**AGENDA
TECHNICAL REVIEW COMMITTEE (TRC)
November 4, 2025
10:00AM**

A. AdventHealth Sign Variance – Alt Key 1288088

**MINUTES
TECHNICAL REVIEW COMMITTEE (TRC)
October 7, 2025
10:00AM**

SIGN PACKAGE

PROJ. NO.	14.2011.00	SHEET
DRAWN	BBY	
		A210

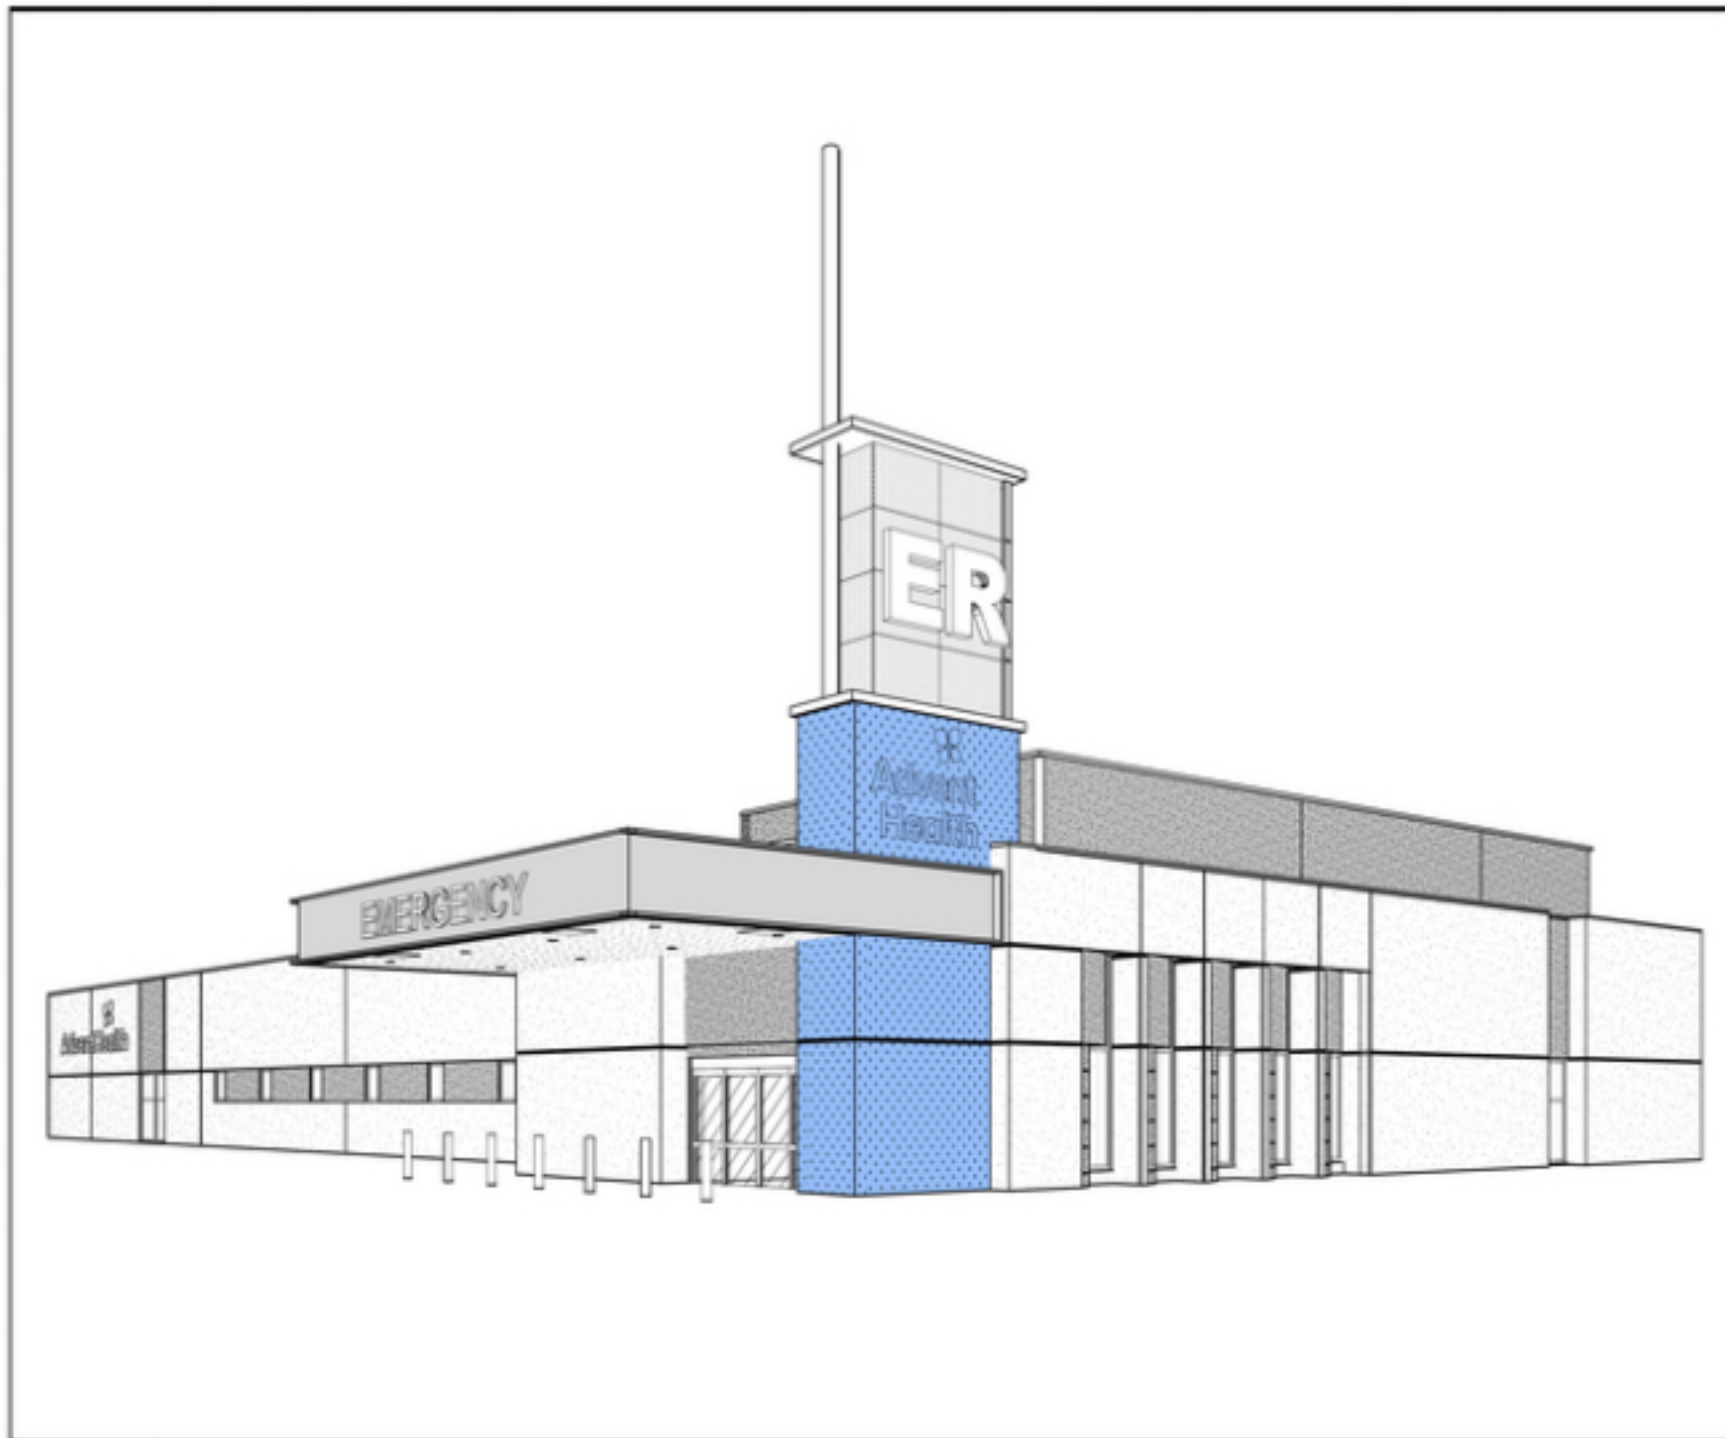
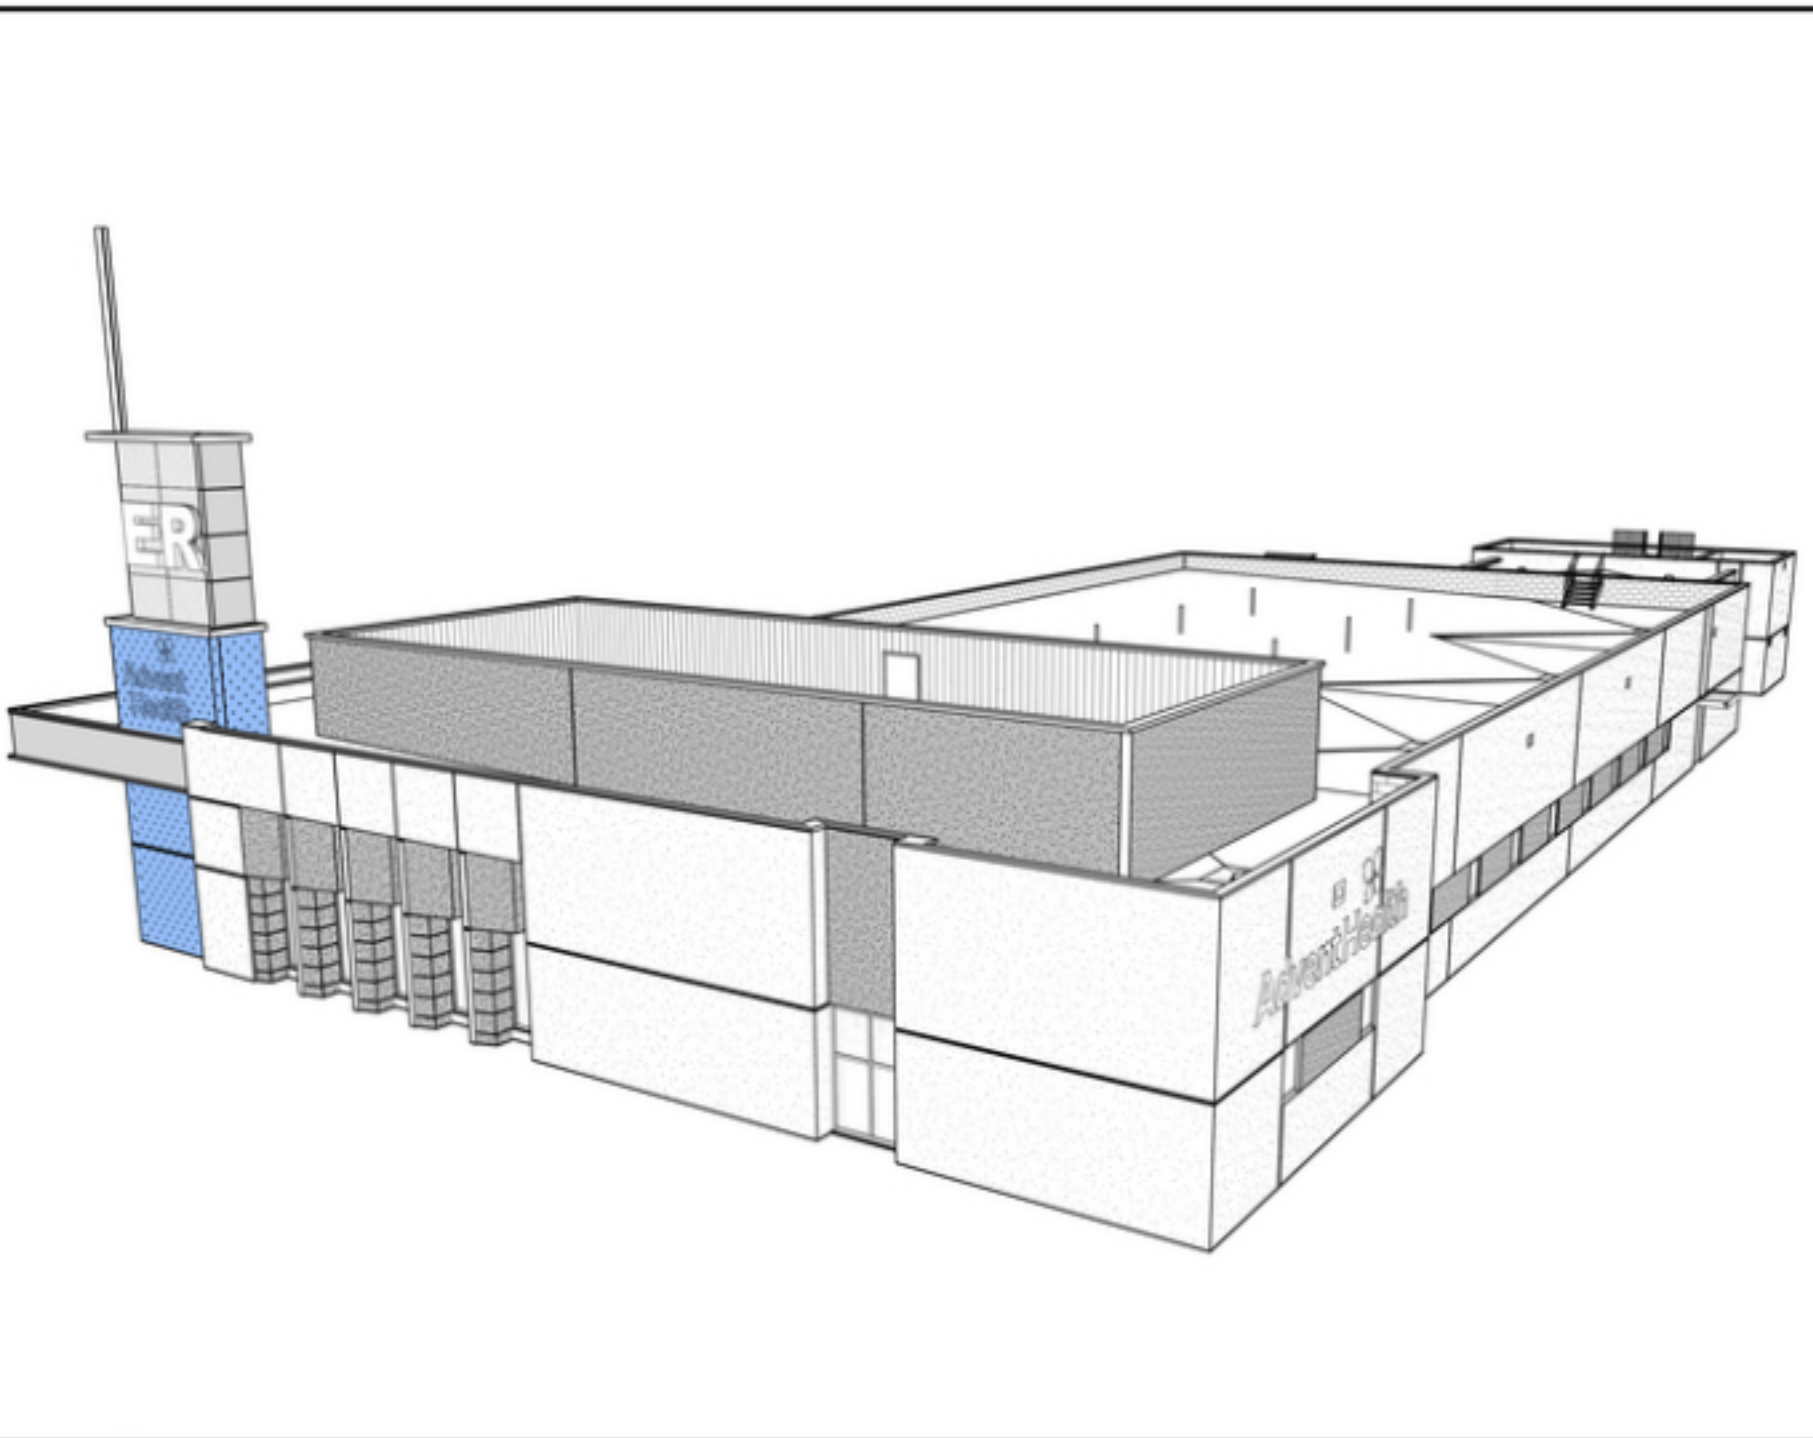
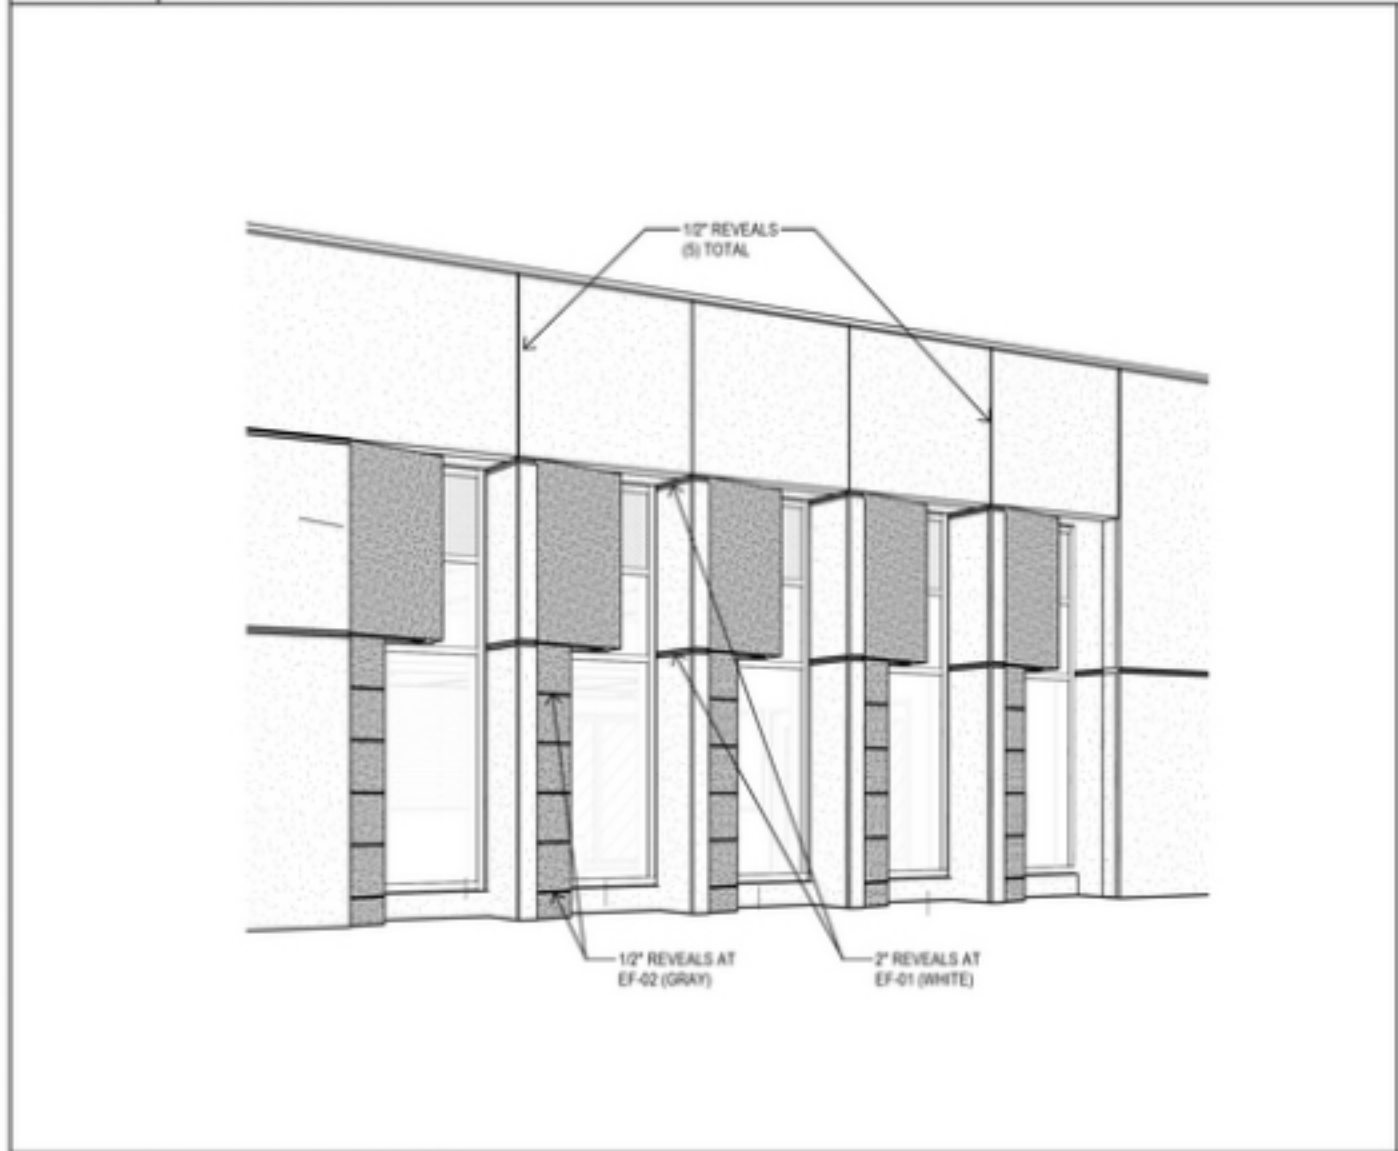
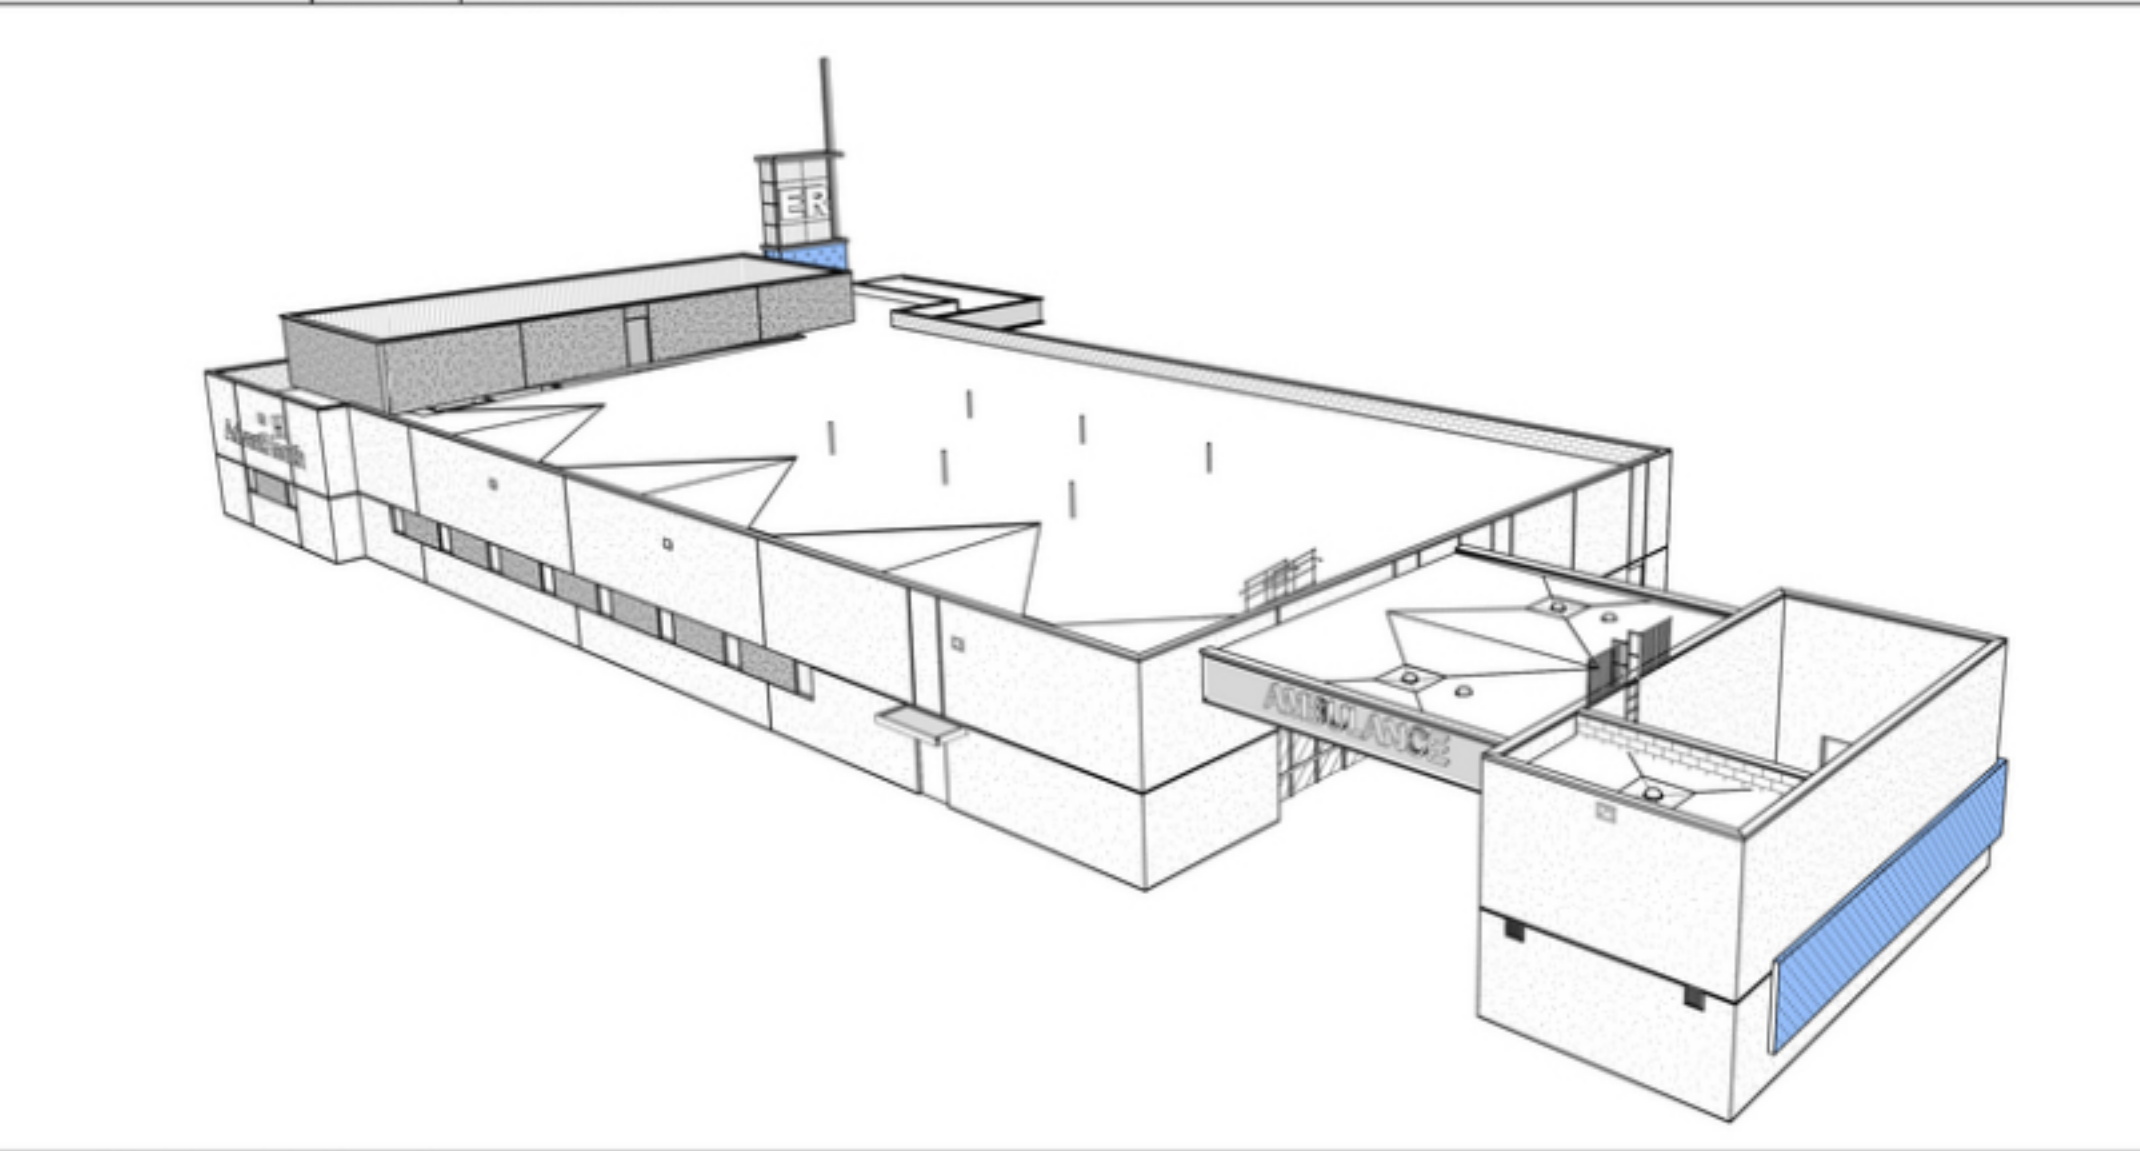
The spire is oriented such that it faces South/North rather than East/West. Because of the turn on CR 466A, the ER sign is harder to see. Illuminating it would make the building much easier to find. We're requesting approval to internally illuminate the south-facing ER portion of the spire/architectural feature. I've included a few screen shots from the construction drawings to provide a visual of the ER orientation on the building.

This makes the statement in the resolution about the ER lettering on the beacon sign facing westward invalid; we are requesting that the ER lettering be illuminated facing **south**.
